Friday, February 28, 2003
Document Control Desk
U.S. Nuclear Regulatory Commission
Washington, D.C. 20555

Ref: Docket 50-27

This letter is a response to a U.S. Nuclear Regulatory Commission request for additional information dated January 9, 2003.

Figure: Pressure Sensor Positions Relative to the "Absolute Filter"

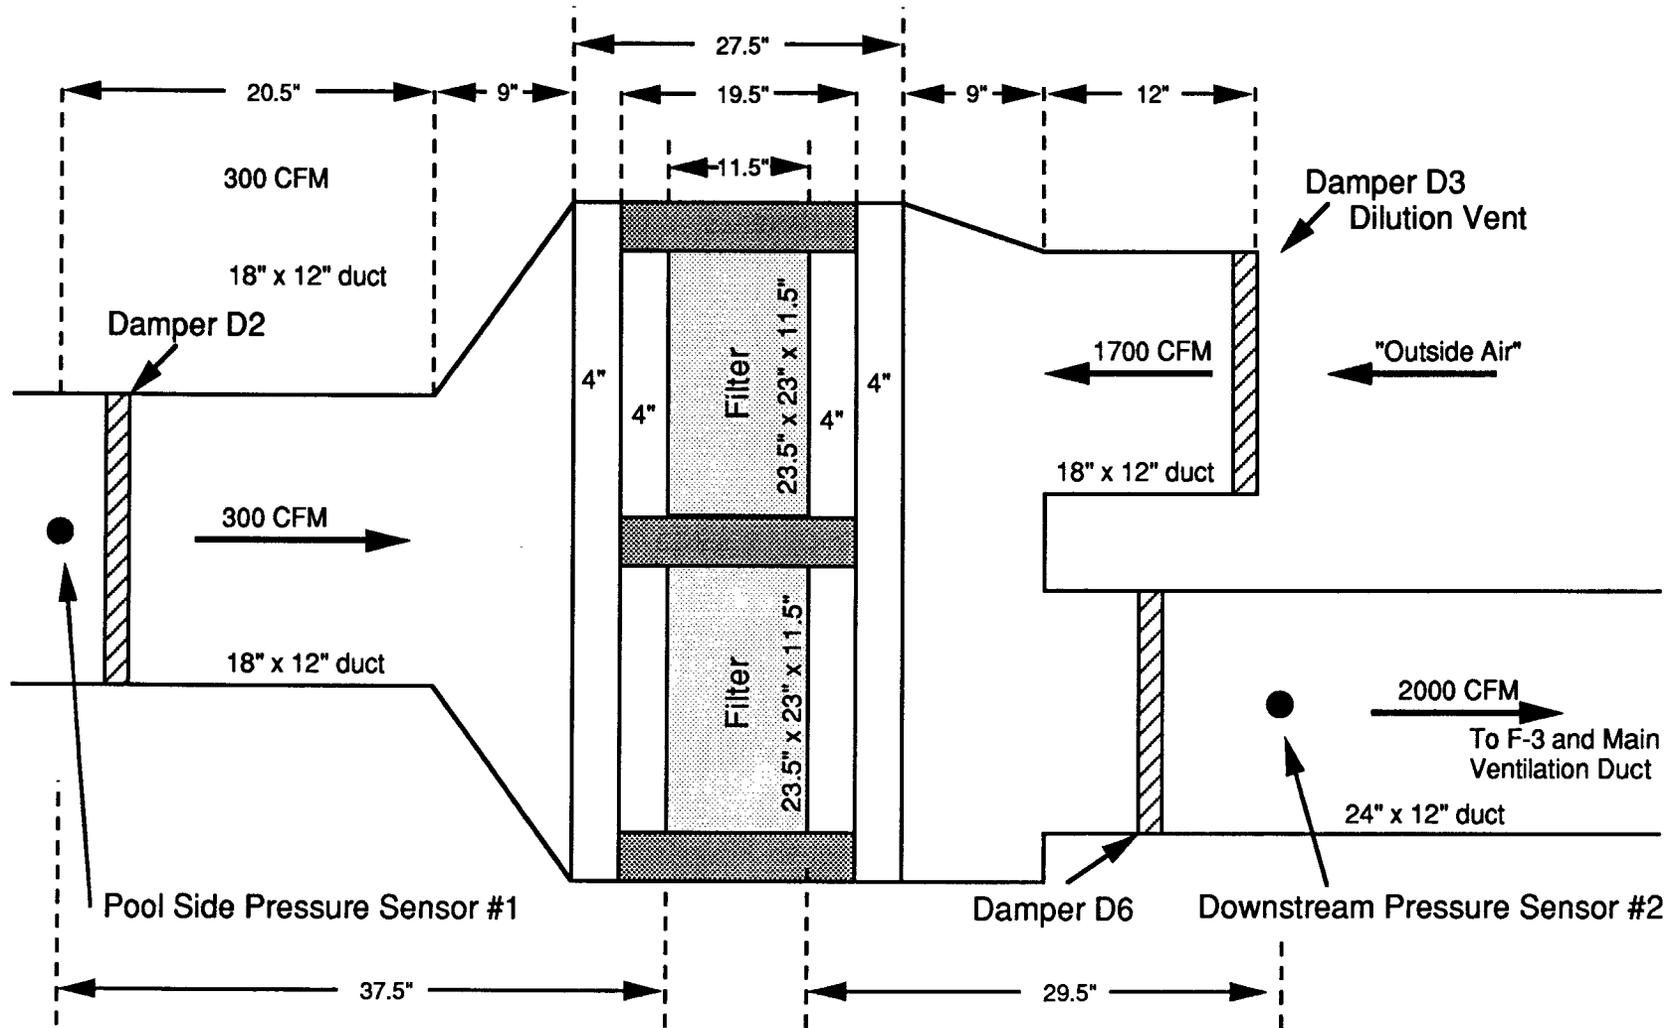
1. According to your request to change the Technical Specifications (Amendment No. 18) the new criterion to replace the "absolute filter" will be based purely in the performance of the filter. The pressure drop caused by the "absolute filter" will be the only indicator to ensure that the filter performance is acceptable. Figures 9-1 and 9-2 of the Safety Analysis Report are inconsistent on where the Pressure Elements (PE) are installed with respect to the "absolute filter." Please provide a detailed diagram of the installation of the two pressure elements used to calculate the pressure drop caused by the "absolute filter." This diagram should illustrate the section of the HVAC system that is used in the "dilute mode." The following detailed information should be included with this illustration:

- (a) duct dimensions where the "absolute filter", the first pressure element, and second pressure element are installed, and
- (b) the distances between the two pressure elements and the "absolute filter."

Attached is a more detailed diagram entitled, "Pressure Sensor Positions Relative to the 'Absolute Filter'". On this diagram one can see the position of the pressure sensor on the pool side of the absolute filter. In the dilute mode, 300 CFM is being drawn from the pool room. It then passes the first pressure sensor located 37 1/2" upstream of the absolute filter. The filter consists of two side by side box shaped objects of dimension 23 1/2" x 23 1/2" x 11 1/2" oriented as shown. The second pressure sensor in the diagram is located 29 1/2" downstream of the absolute filter in the duct leading to the main ventilation system exhaust. In the dilute mode, 300 CFM of pool room air is passed through the HEPA filter and then mixed with 1700 CFM of "outside air" to produce a "dilution" factor of 6.67 when the filter is new. If the HEPA filter becomes slightly obstructed

through use, the dilution factor would become larger and therefore the radioactive air release rate would become more conservative. After dilution, the mixed air passes through damper D-6 and enters fan F-3 which draws the air into the main ventilation duct where the "Exhaust Gas Monitor" measures the Argon-41 release. The total distance between the two pressure sensors is 78.5".

REVISIONS				NUCLEAR RADIATION CENTER WASHINGTON STATE UNIVERSITY PULLMAN, WASHINGTON	
				TITLE: BEAM ROOM SCRAM CHAIN	
SCALE: N.A.		DWG BY: G.E.T.		FILE NO: 5	
DATE: 07/30/2001		CHK BY: G.E.T.

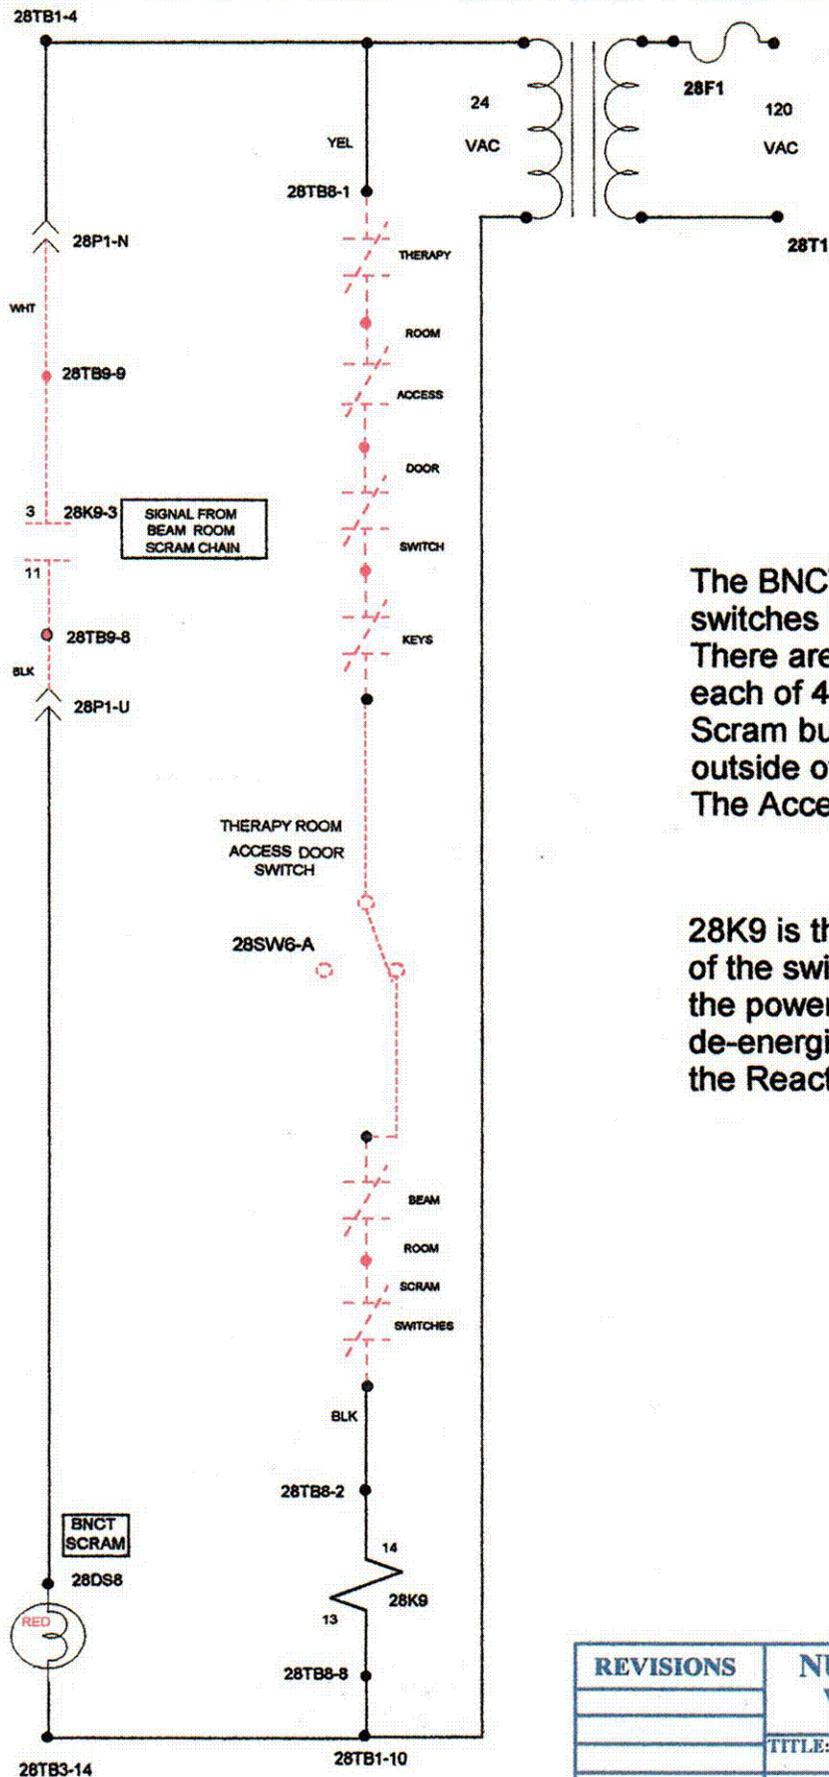
4. Please provide more information regarding the second change you are proposing in the requested amendment of the TSs, and explain why these two items are redundant. Include information on the control and instrumentation system activated by the access gate mentioned in the items 10.c and 10.d of Section 3.15 of the TSs.

This action was accomplished by placing a spring loaded micro-switch on the inside door frame of the access gate (which is actually a solid door). The micro-switch is Normally Closed (NC) when the switch is compress by a plate attached to the access gate (see switch 28SW6-A on the drawing "Beam Room Scram Chain"). The switch is NC when the gate is closed by this plate attached to the gate. If the access gate is opened a few millimeters, the micro-switch 28SW6-A changes to the "Open" state. This switch is part of the Beam Room scram chain. If any element in this scram chain opens, the reactor automatically scrams and the bridge automatically retracts. This micro-switch is actually the switch referred to in 10.d that describes it as "the bridge retraction switch on the access gate".

That means that "opening the access gate" in 10.c and "opening the bridge retraction switch" in 10.d are one and the same action; hence the redundancy.
